SUBJECT: **Addendum No. 2**

RE: Invitation to Bid (ITB) Solicitation No. H93-IAHARR-2024-025, IAH Terminal A Restrooms Upgrades at George Bush Intercontinental Airport (IAH); Project No. 1009

**Addendum No. 2**

IAH Terminal A Restrooms Upgrades at George Bush Intercontinental Airport (IAH)

SHEET NAME: MECHANICAL OVERALL PLAN - LEVEL 1  
SHEET No. M1.11 SCALE: 1" = 60'-0"  
SHEET SIZE: 30"x42" ARCH E1

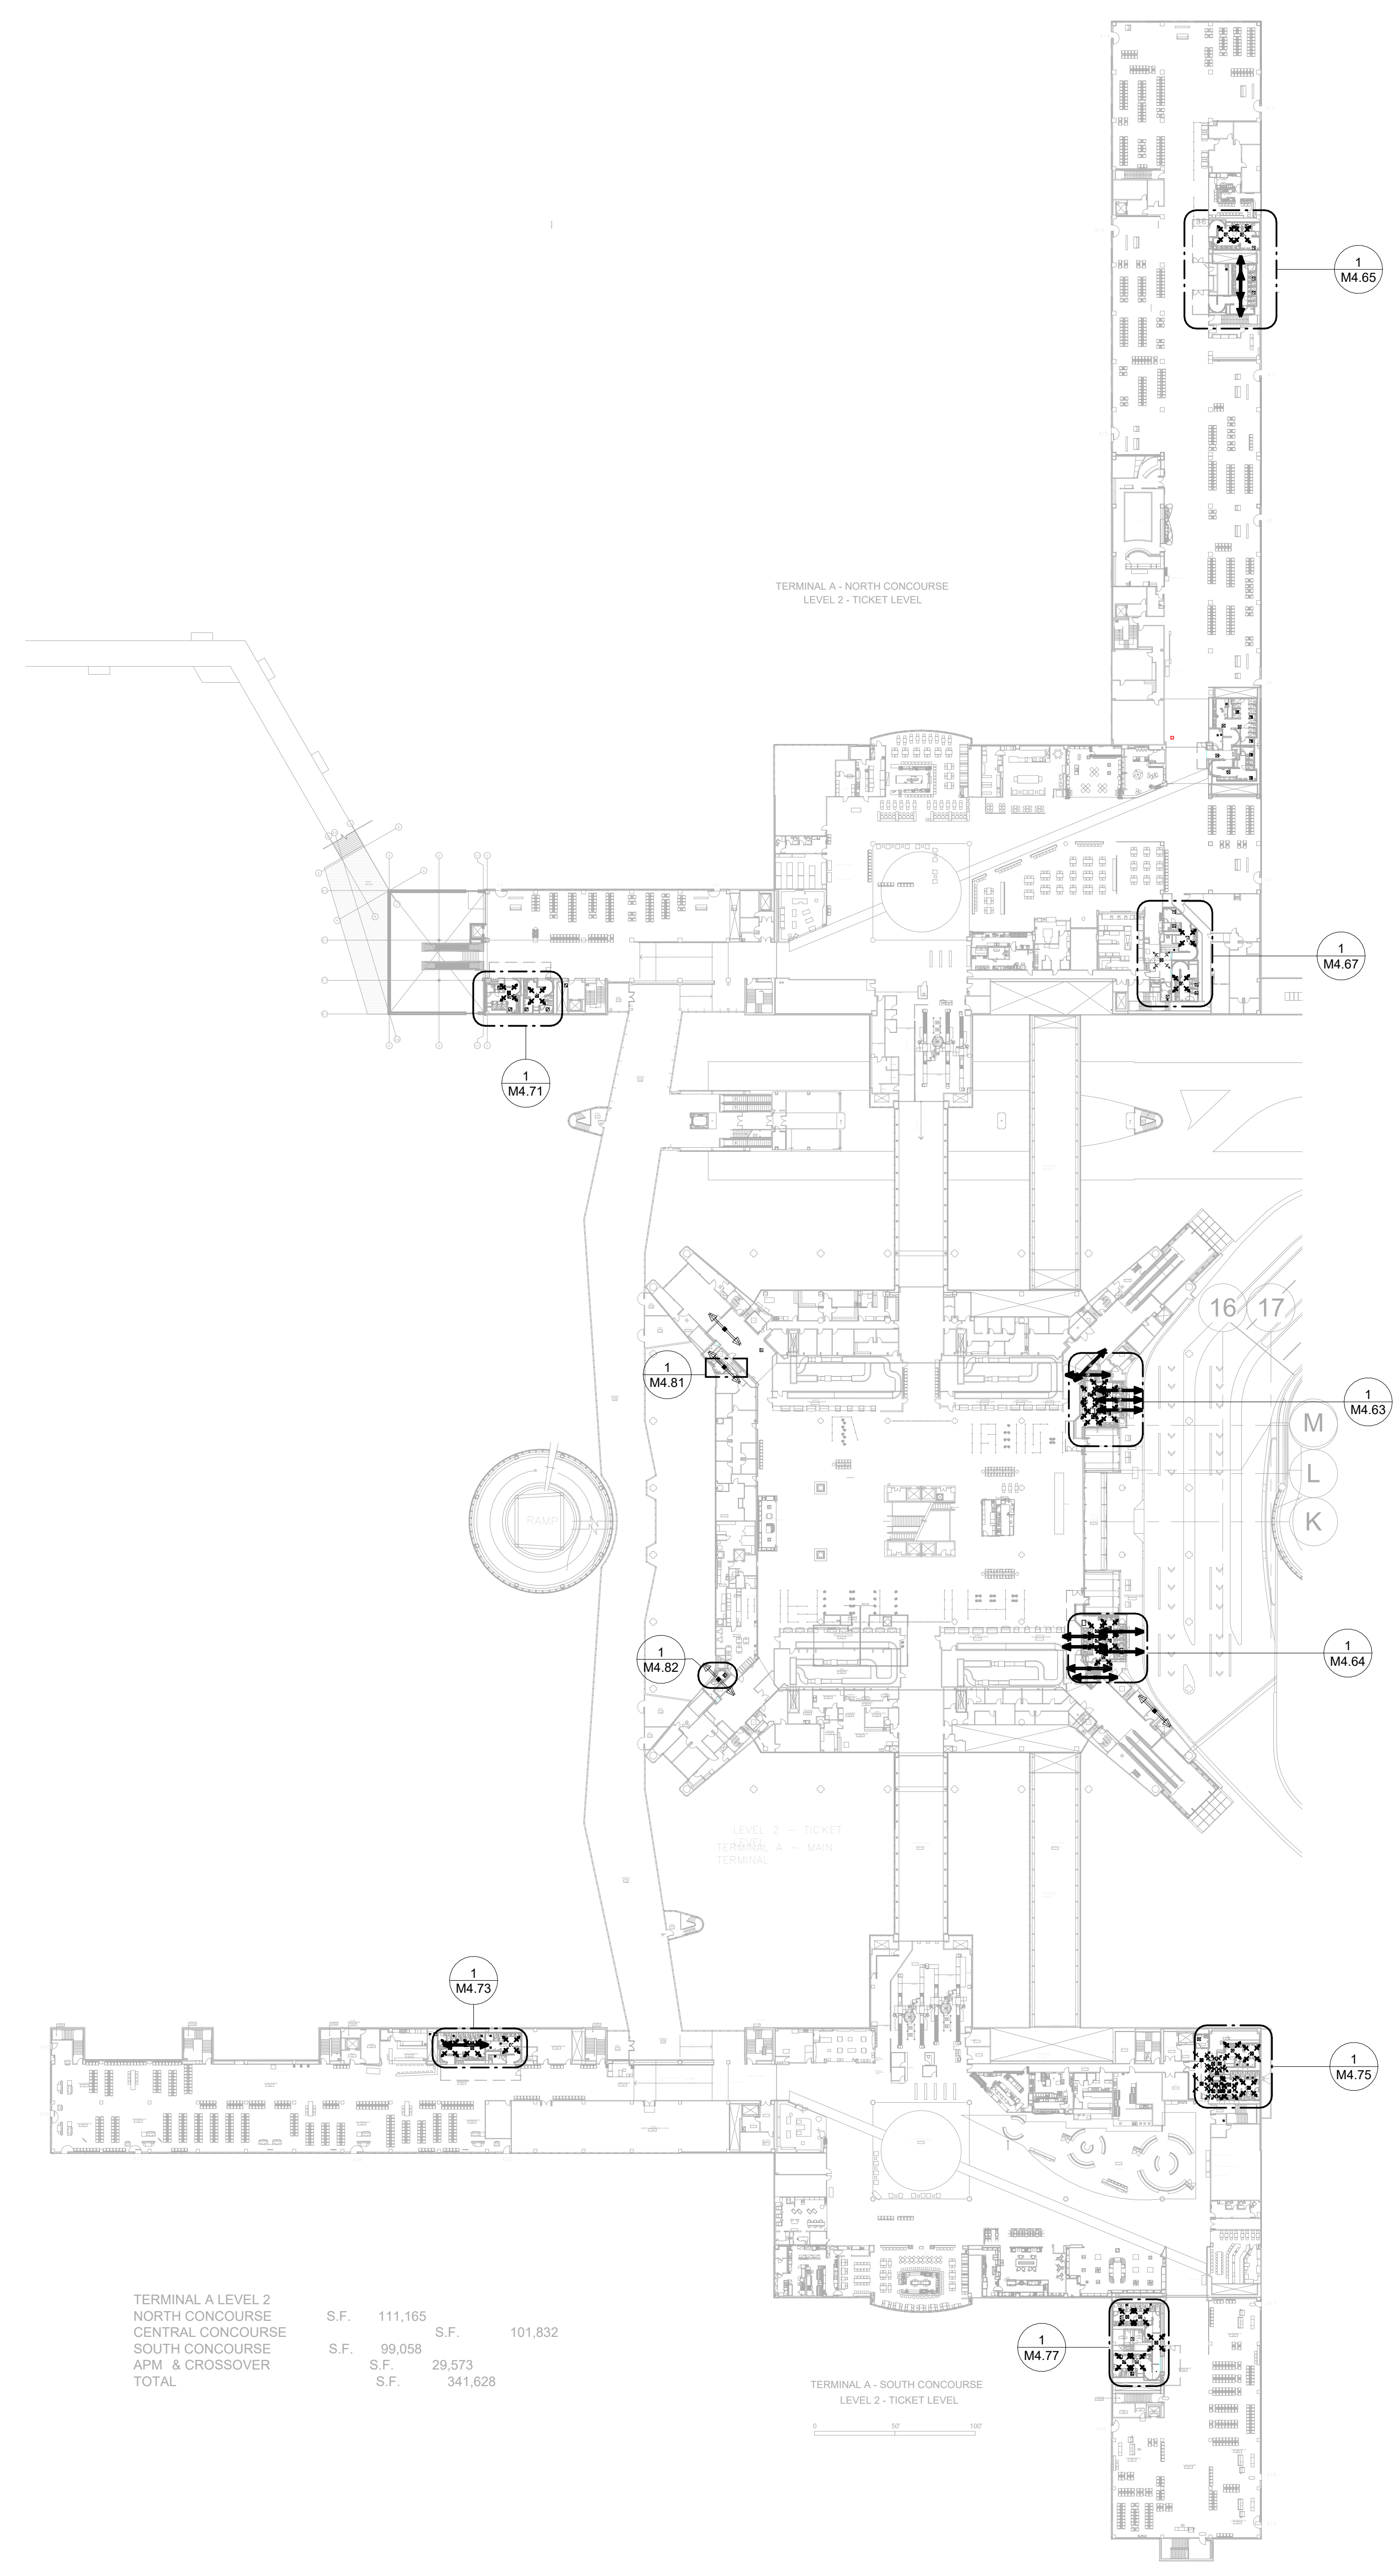
M1.11: Added new Callouts.

SHEET NAME:  
ELECTRICAL LIGHTING ENLARGED PLAN - RR 1 & 2  
SHEET No. EL4.61 SCALE: As indicated

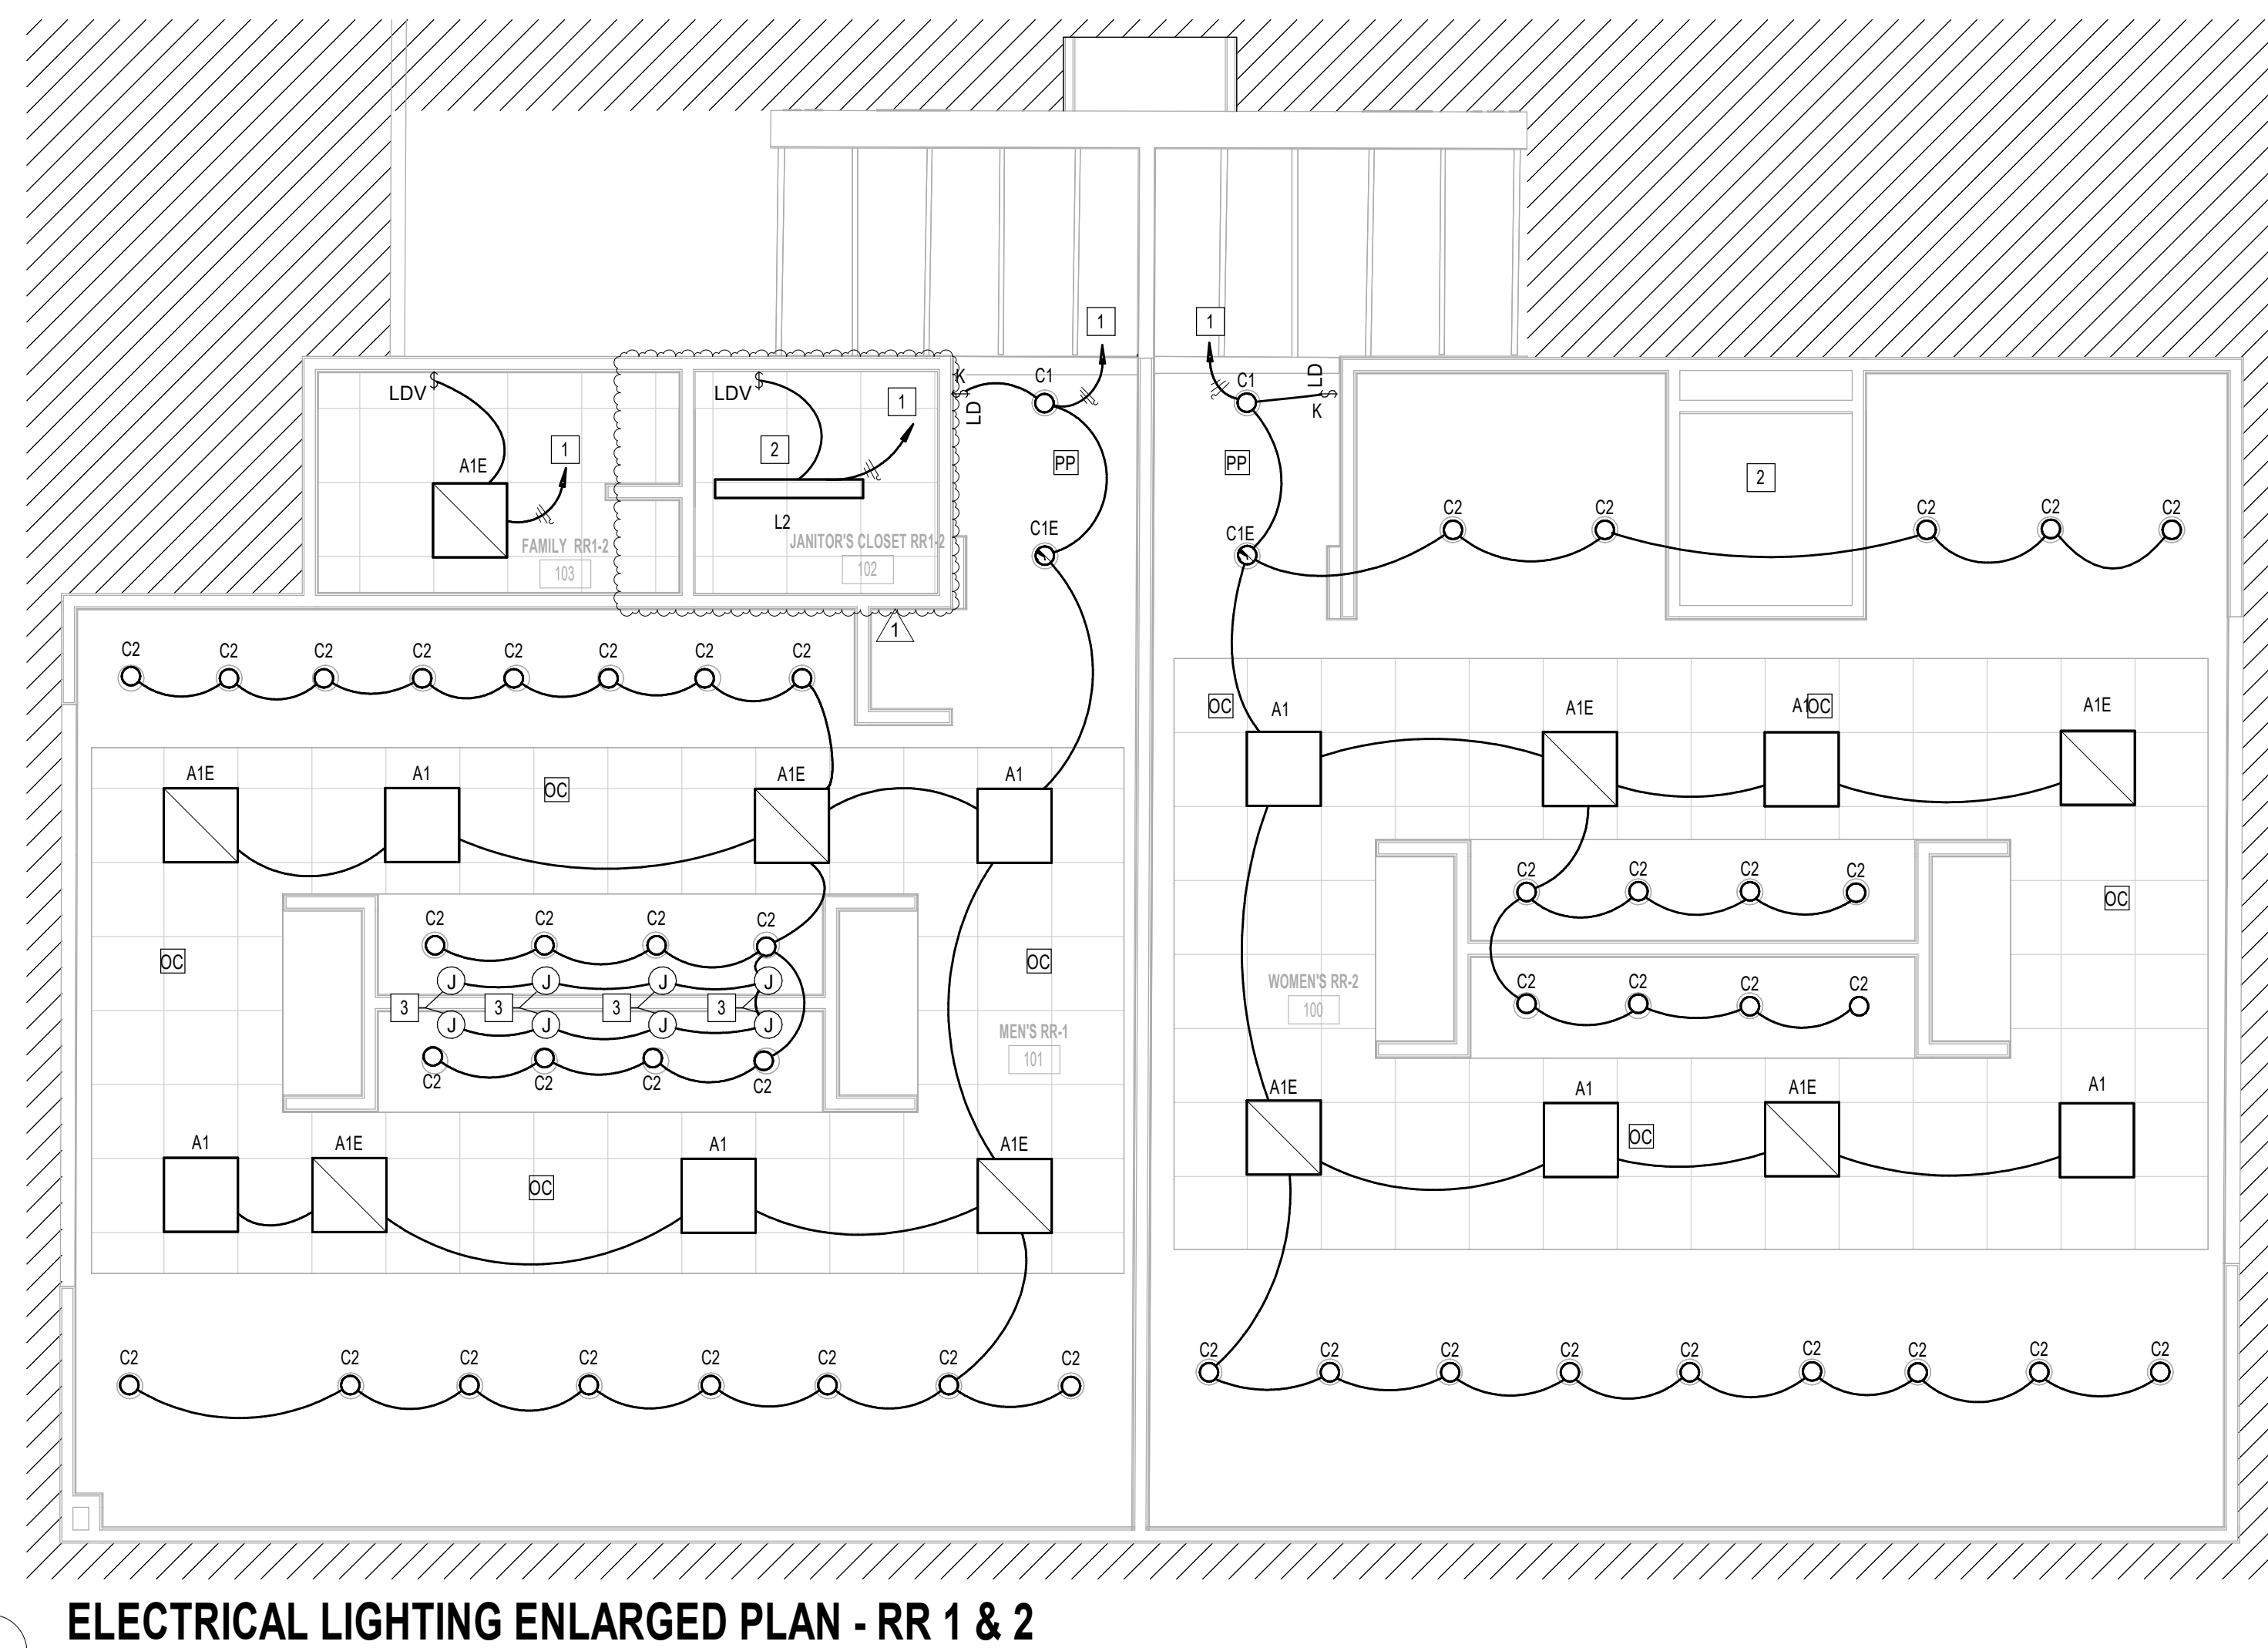
EL4.61: Added lighting to janitor closet.

SHEET NAME: PLUMBING OVERALL PLAN - LEVEL 1  
SHEET No. P1.11 SCALE: As indicated  
SHEET SIZE: 30"x42" ARCH E1

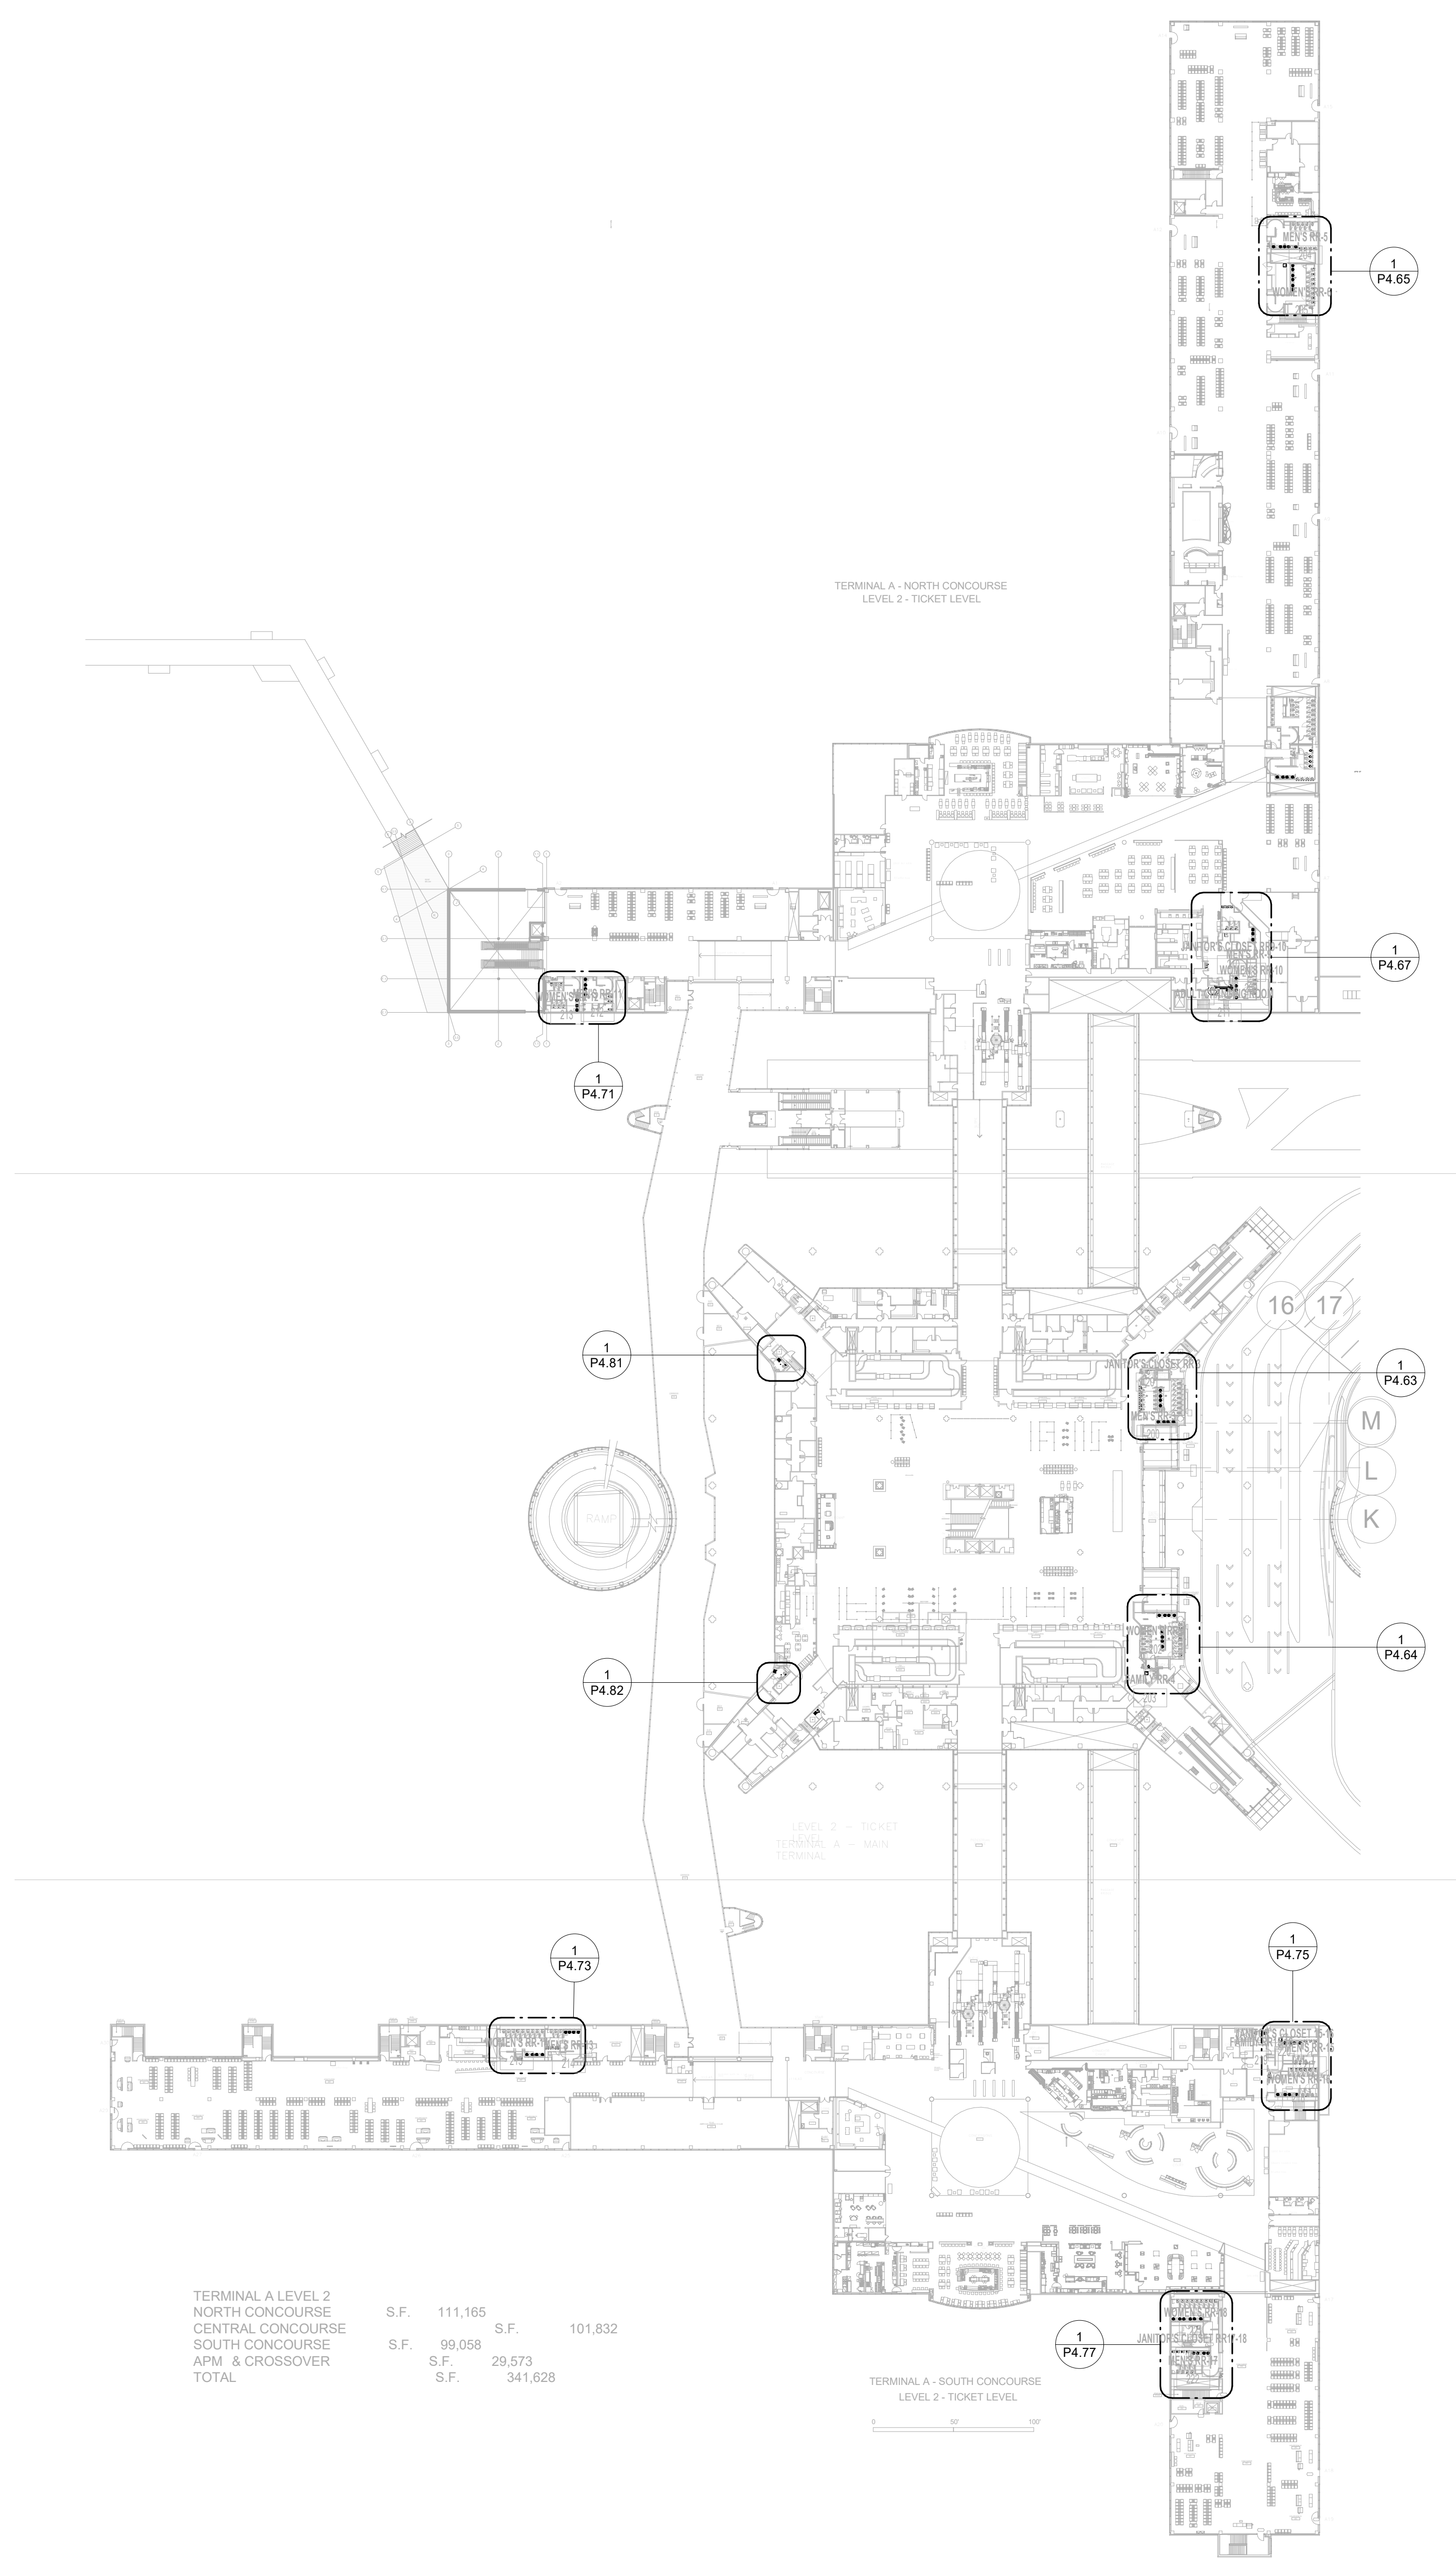
P1.11: Added notes.
